Subject: ADA Assessment of City Library and Senior Center

**City of South Pasadena
Disabled Access Assessment
for the
Library and Senior Center**

Prepared by
Transtech Engineers, Inc.
April 21, 2006

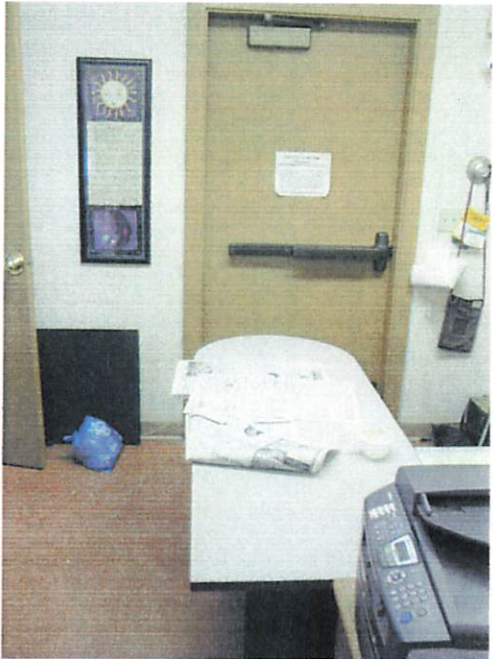
Image	Description	Associated Code Section¹
<p>1.</p> 	<p>Location: Between administrative area and west side patio area – southern sliding door.</p> <p>Noncomplying Condition: Door threshold.</p> <p>Effort to Correct: Significant</p> <p>Cost to Correct: \$\$\$\$</p> <p>Suggested Corrective Action: Relevel the unmortared brick patio at just below interior floor level and replace the siding glass door with a complying sliding glass door or fill opening with a window and complying swinging door.</p>	<p><u>CBC</u> 2-1133B.1.1.1 2-1133B.2.4.1</p> <p><u>ADAAG</u> 4.13.8</p>

<p>Location: Between administrative area and west side patio area – northern sliding door.</p> <p>Noncomplying Condition: Door threshold.</p> <p>Effort to Correct: Significant</p> <p>Cost to Correct: \$\$\$\$</p> <p>Suggested Corrective Action: Relevel the unmortared brick patio at just below interior floor level and replace the sliding glass door with a complying sliding glass door or fill opening with a window and complying swinging door.</p>	<p><u>CBC</u> 2-1133B.1.1.1 2-1133B.2.4.1</p> <p><u>ADAAG</u> 4.13.8</p>
<p>3.</p> 	<p>Location: Various locations throughout the building.</p> <p>Noncomplying Condition: Door knob.</p> <p>Effort to Correct: Negligible</p> <p>Cost to Correct: \$</p> <p>Suggested Corrective Action: Replace noncomplying door knobs with complying lever door hardware.</p>	<p><u>CBC</u> 2-1133B.2.5.2</p> <p><u>ADAAG</u> 4.13.9</p>

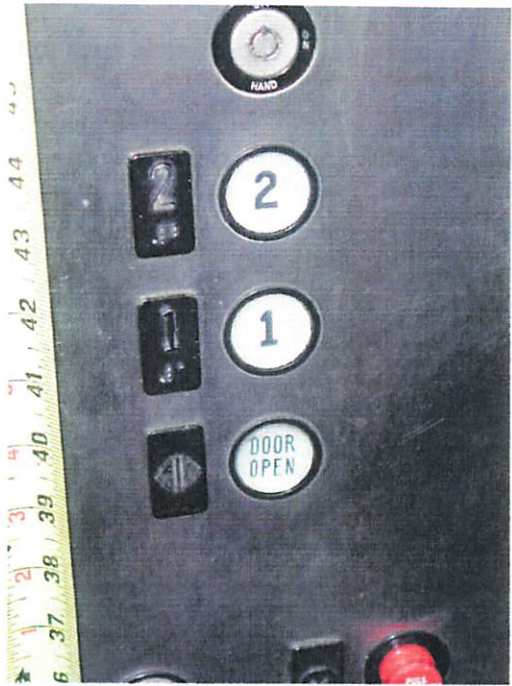
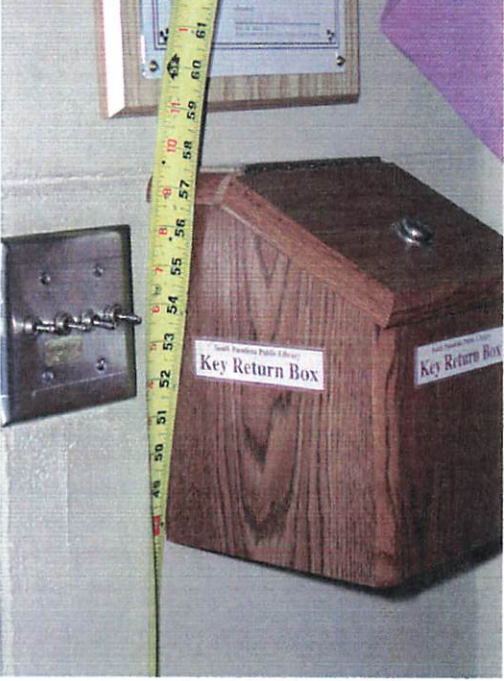
Image	Description	Associated Code Section ¹
<p>1. </p>	<p>Location: Interior stair to second floor.</p> <p>Noncomplying Condition: Handrails and stair level signage. No visual striping.</p> <p>Effort to Correct: Minor</p> <p>Cost to Correct: \$\$</p> <p>Suggested Corrective Action: Replace handrails with complying handrails mounted at the correct height.</p>	<p style="text-align: center;"><u>CBC</u> 2-1133B.4.2.1 2-1133B.4.2.2 2-1133B.4.2.6.1 2-1133B.4.3 2-1133B.4.4 2-1117B.5</p> <p style="text-align: center;"><u>ADAAG</u> 4.9.4</p> <p style="text-align: center;"><u>CBC</u> <u>Tactile Exit Signage</u> <u>Requirements</u>² 2-1003.2.8.6 2-1003.2.8.6.1</p>

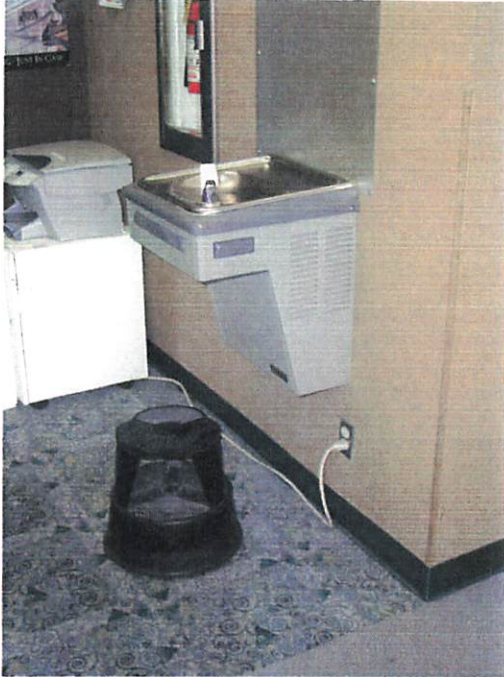
<p>2.</p> 	<p>Location: Library Elevator.</p> <p>Noncomplying Condition: Lack of raised button. No braille information. No star at ground floor.</p> <p>Effort to Correct: Minor</p> <p>Cost to Correct: \$\$</p> <p>Suggested Corrective Action: Replace button with complying button.</p>	<p><u>CBC</u></p> <p><u>ADAAG</u> 4.10.3 4.10.12</p>
<p>3.</p> 	<p>Location: Library Elevator.</p> <p>Noncomplying Condition: No hall lantern. No raised braille characters on each side of entrance. Noncomplying audible signals and car position indicators.</p> <p>Effort to Correct: Minor to Significant.</p> <p>Cost to Correct: \$\$\$</p> <p>Suggested Corrective Action: Install appropriate information and/or systems.</p>	<p><u>CBC</u></p> <p><u>ADAAG</u> 4.10.4 4.10.5 4.10.13</p>

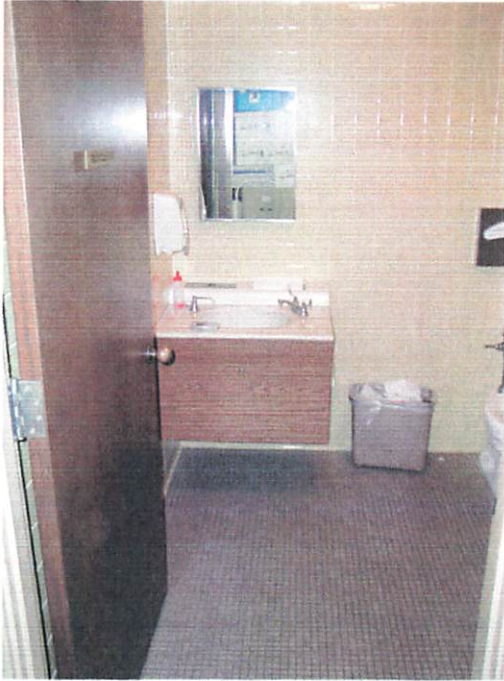
<p>12.</p> 	<p>Location: Door threshold to first floor electric/telecomm room.</p> <p>Noncomplying Condition: Door threshold height. (Existing condition also violates California Building Code door threshold height requirements.)</p> <p>Effort to Correct: Minor</p> <p>Cost to Correct: \$ to \$\$</p> <p>Suggested Corrective Action: Remove and replace with a complying door threshold.</p>	<p><u>CBC</u> 2-1133B.2.4.1</p> <p>2-1003.3.1.6 (exiting)</p> <p><u>ADAAG</u> 4.13.8</p>
<p>13.</p> 	<p><i>San Marino</i></p> <p>Location: First floor level.</p> <p>Noncomplying Condition: Magazine and card catalogs exceed 54 inches maximum reach condition.</p> <p>Effort to Correct: Minor</p> <p>Cost to Correct: \$\$ to \$\$\$</p> <p>Suggested Corrective Action: Install complying displays and catalogs.</p>	<p><u>ADAAG</u> 8.4</p>
<p>14.</p> <p>No Photograph</p>	<p>Door closers should not require more than 5 pounds to operate except that fire-rated door assemblies may require not more than 15 pounds of force to operate. All doors not in compliance should be adjusted or have the closer replaced.</p>	<p><u>CBC</u> 2-1133B.2.5 2-1133B.2.5.1 2-1133B.2.5.2</p> <p><u>ADAAG</u> 4.13.10 4.13.11</p>

25.

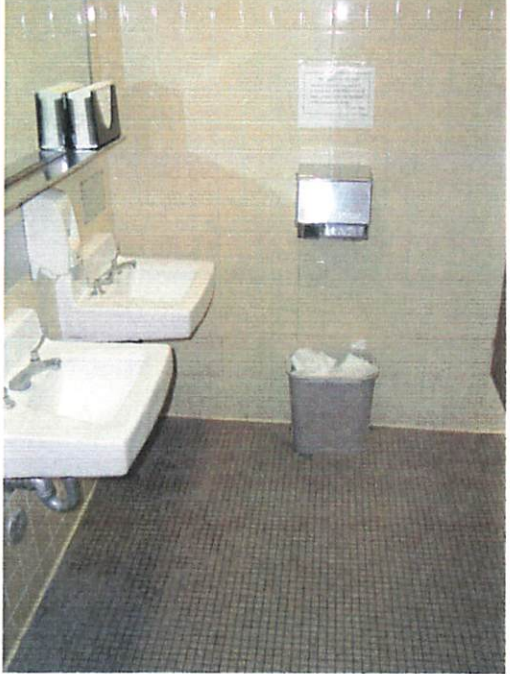
Effort to Correct: Significant to Major.

Cost to Correct: \$\$\$\$

Suggested Corrective Action:
Option No. 1: Reconfigure stall by moving tile wall closer to the toilet and moving the partition wall further away from the toilet. (Moving the partition may make the adjacent stall unusable, which may then require that the adjacent urinal be eliminated or that both urinals be moved.)¹
Option No. 2: Relocate the toilet to a complying location and move the partition wall. (As before, moving the partition may make the adjacent stall unusable, which may then require that the adjacent urinal be eliminated or that both urinals be moved.)¹

28.

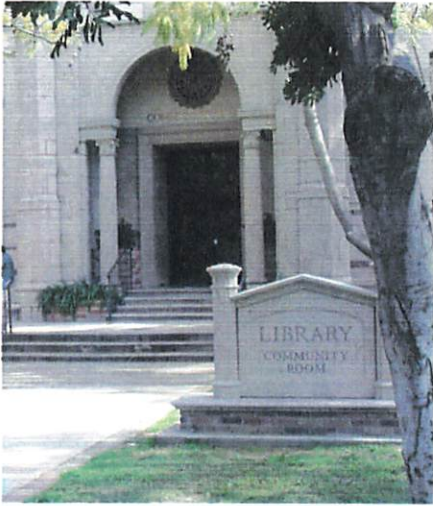
Effort to Correct: Significant to Major.

Cost to Correct: \$\$\$\$

Suggested Corrective Action:
Option No. 1: Reconfigure stall by moving tile wall closer to the toilet and moving the partition wall further away from the toilet. (Moving the partition may make the adjacent stall unusable, which may then require that the adjacent urinal be eliminated or that both urinals be moved.)¹
Option No. 2: Relocate the toilet to a complying location and move the partition wall. (As before, moving the partition may make the adjacent stall unusable, which may then require that the adjacent urinal be eliminated or that both urinals be moved.)¹

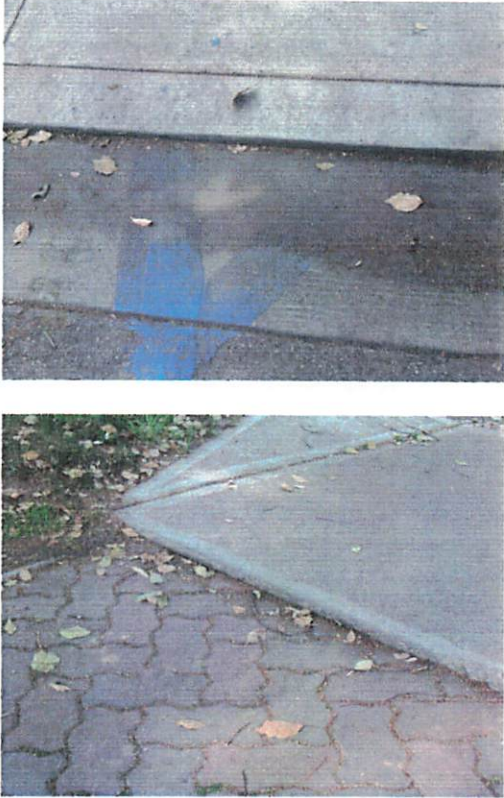
Effort to Correct: Negligible to Minor

Cost to Correct: \$ to \$\$

Suggested Corrective Action: Install a similar wrought iron element in the center of the opening which reduces the opening area to a dimension that is not greater than that provided by the vertical pickets of the existing guardrail.
